DART SERVICE INSTRUCTION

TO AMEND INSTALLATION INSTRUCTIONS D412-673 REV. A

REF. CANADIAN STC: SH96-88 REF. FAA STC: SR00563NY

FIGURE 1 - TYPICAL BHT ELECTRIC STEP INSTALLATION

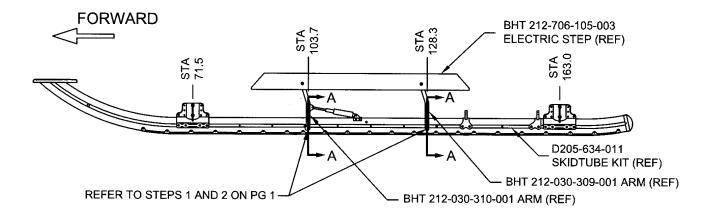
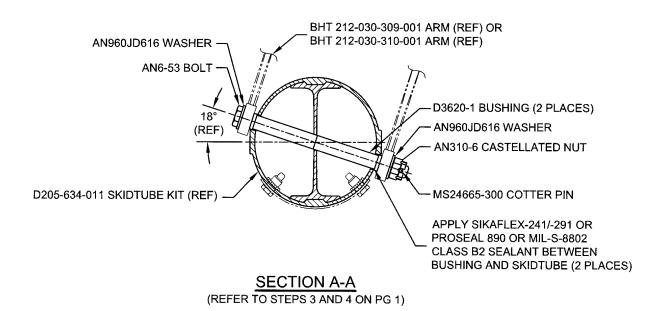
DSI-9374-011 Electric Step Bushing Kit was created to prevent possible wear of the D205-634-011 Skidtube Kit and/or loosening of the ALS7 inserts (provided in the D412-673-011 Electric Step Kit) during normal operation of the BHT 212-706-105-003 Electric Step. The DSI kit replaces the existing ALS7 inserts and hardware with qty(4) D3620-1 Bushings and associated hardware.

- 1) Disconnect the BHT 212-075-418-001 and/or BHT 212-075-418-003 Actuators from the Dart D205-634-011 Skidtube Kit per the Aircraft Maintenance Manual. Remove and discard the qty(4) BHT 212-030-119-001 bolts that fasten then BHT 212-030-309-001 and BHT 212-030-310-001 Arms to the skidtube as shown in *Figure 1* and temporarily move the electric step away from the skidtube.

- 2) Drill out the qty(4) ALS7-428-165 inserts installed in the skidtube at the two locations shown in *Figure 1*. Drill a Ø0.406" pilot hole through the insert holes and the web in the centre of the skidtube. Enlarge the holes to Ø0.438" +0.006" __0.000". Deburr and touch up the holes per ICA-D205-634.

- 3) Install the D3620-1 Bushings into each hole (4 places) with Sikaflex-241/-291 or Proseal 890 or MIL-S-8802 Class B2 sealant as shown in **Section A-A**.

- 4) Re-install the electric step by connecting the BHT 212-030-309-001 and BHT 212-030-310-001 Arms as shown in **Section A-A**. Ensure all nuts are installed on the inboard side of the skidtube. Re-attach the BHT 212-075-418-001 and/or BHT 212-075-418-003 Actuators to the skidtube per the Aircraft Maintenance Manual.
